**CITY OF SEATTLE
ANALYSIS AND DECISION OF THE DIRECTOR
OF THE DEPARTMENT OF PLANNING AND DEVELOPMENT**

Project Number: 3011809 and 3012007
Applicant: Lana Lisitsa of Mithun for The Polyclinic
Address: 751 Marion Street and 800 7th Avenue

Land Use Application to allow a two-story parking garage with 351 parking spaces and surface parking for 49 vehicles. Project includes 25,700 total cu. yds. of grading and alley improvements. Environmental review for #3012007 to be conducted under #3011809.

View from the alley at Columbia Street, looking at the proposed garage's west wall

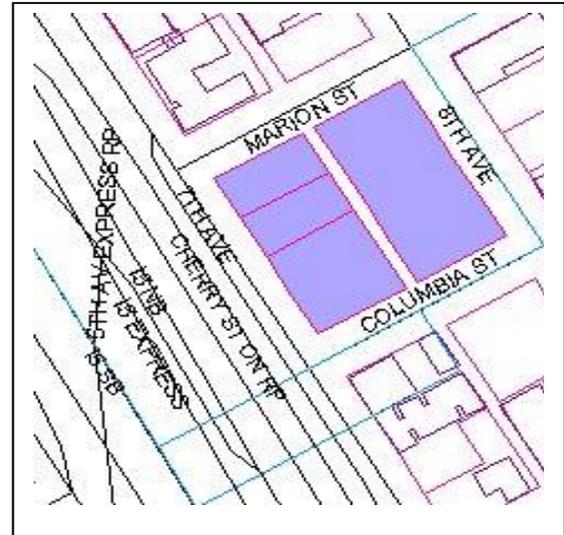
The west façade of the parking garage included colored translucent polycarbonate panels in a variety of textures and mounted at a variety of depths from the parking garage façade. The panels would be wrapped in metal on the edges for the purposes of mounting to the garage structure and in the northwest pocket park. The light standards at the top of the parking garage would shine down on these panels at night, providing interesting color and safety. The light fixtures would be maximum 12' high at the east side of the alley, consistent with nearby light fixtures in First Hill. The stair towers were clad in ground face concrete masonry units (CMU), with the vent shaft integrated into the stair tower.
